Subject: **FCC Class II Permission Change Request for FCC ID: 2ATEV-BL1206-P**

This is to request a Class II Permission Change Request for FCC ID: 2ATEV-BL1206-P, originally granted on 2020/08/11

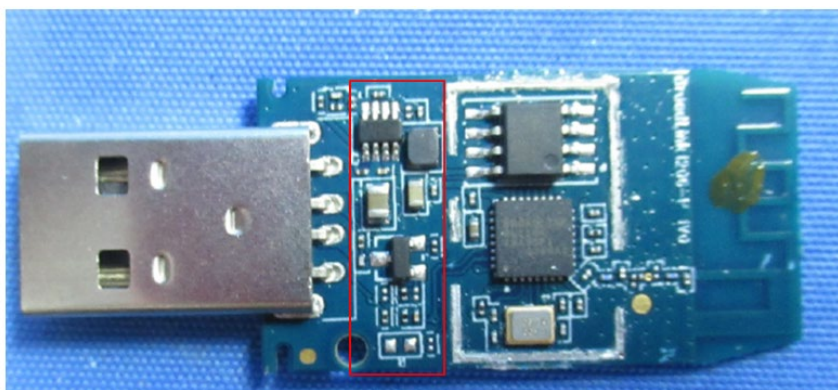
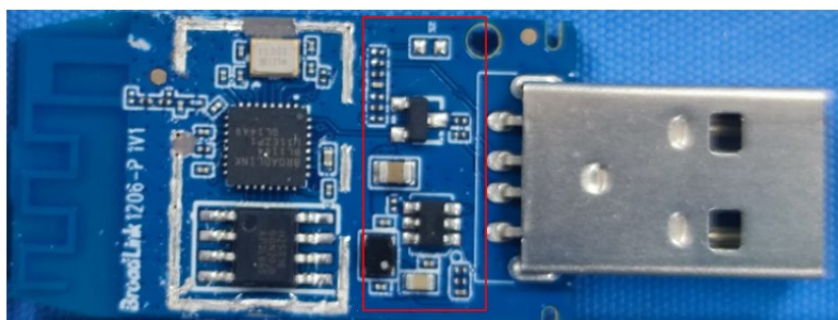
1.The DCDC used on 1V0 is MP2318, and the DCDC use on 1V1 is SGM61410. Because the DCDC has been changed, so the peripheral circuits are changed too.

Before(1V0):

Now(1V1):
